Access Compliance Report

Public Rights-of-Way (Curb Ramps)

Intersection ID: 6263	Main Street: W_SUGAR_CREEK_RD	Cross Street: RUMPLE_RD	Location:	SE
ADA ID: 52A81F7E45D0	Ramp Type: Combination2	Initial Pass/Fail: Fail	Overall Compliance: No	Severity Score: 25

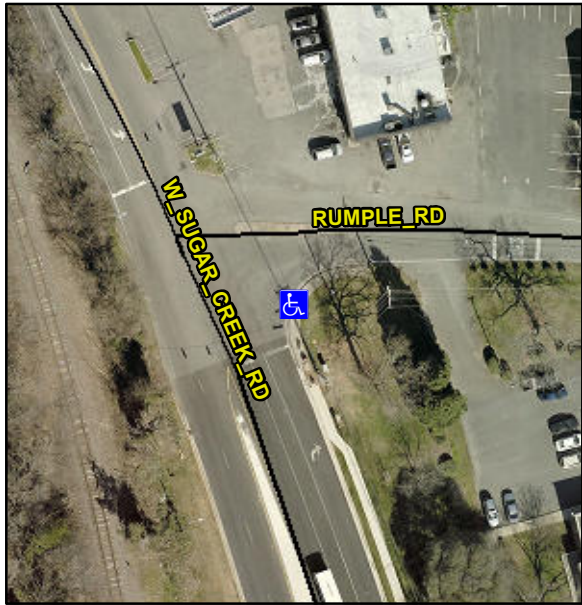
Codes/Mitigation Info/Possible Solution			Field Measurements/Component Compliance					
	Possible Solutions:		Compliance	Description	Data	Compliance	Description	Data
	Remove & Replace Entire Ramp.		N/A	Ramp Length LT (in)	26.5	N/A	Ramp Length RT (in)	N/A
			Yes	Ramp Width LT (in)	56.0	N/A	Ramp Width RT (in)	N/A
			Yes	Ramp Slope LT (%)	5.6	N/A	Ramp Slope RT (%)	N/A
			No	Ramp XSlope LT (%)	6.3	N/A	Ramp XSlope RT (%)	N/A
			N/A	Ramp Length (in)	60.0	No	Ramp Slope (%)	9.0
			Yes	Ramp Width (in)	48.0	Yes	Ramp XSlope (%)	0.7
	Surveyor Notes:		N/A	Flare Type LT	N/A	N/A	Flare Type RT	N/A
	N/A		N/A	Flare Slope LT (%)	N/A	N/A	Flare Slope RT (%)	N/A
			N/A	Flare Traversable LT?	N/A	N/A	Flare Traversable RT?	N/A
			N/A	Landing Length (in)	N/A	N/A	DWS Provided?	N/A
			N/A	Landing Width (in)	N/A	N/A	DWS Contrast?	N/A
	PROW/ADA:		N/A	Landing Slope (%)	N/A	N/A	DWS Length (in)	N/A
	Not Found, R304.2.2, R304.5.3		N/A	Landing X Slope (%)	N/A	N/A	DWS Full Width?	N/A

N/A	Landing Curb? (Y/N)	N/A	N/A	DWS Offset (in)	N/A
			N/A	Shared Landing?	N/A			
			N/A	Gutter Ponding?	N/A	N/A	Gutter Slope (%)	N/A
			N/A	Gutter Lip Ht (in)	N/A	N/A	Gutter X Slope (%)	N/A
			N/A	Painted X Walk1?	No	N/A	Painted X Walk2?	N/A
Street 1 Name		StopSign		X Walk 1 Direction	To NE		X Walk 2 Direction	N/A
Stop Condition-Street 1		W SUGAR CREEK RD		X Walk 1 Width (in)	N/A		X Walk 2 Width (in)	N/A
Street 2 Name		N/A		X Walk 1 Slope (%)	0.2		X Walk 2 Slope (%)	N/A
Stop Condition-Street 2		N/A		X Walk 1 X Slope (%)	1.0		X Walk 2 X Slope (%)	N/A
Total Cost:		\$ 1600.00	N/A	Ramp inside XWalk1?	N/A	N/A	Ramp inside XWalk2?	N/A
				Road Slope (%)	N/A		Clear Space?	N/A
				Road X Slope (%)	N/A	N/A	Clear Space to XWalk (in)	N/A
						N/A	Any Obstruction?	N/A
							Obstruction Type	N/A
						N/A	Storm Grate/Utility Hazard?	N/A
							Storm Grate/Utility Type	N/A
						Yes	Surface Condition? (G/P)	Good
							Curb Slope (%)	16.2
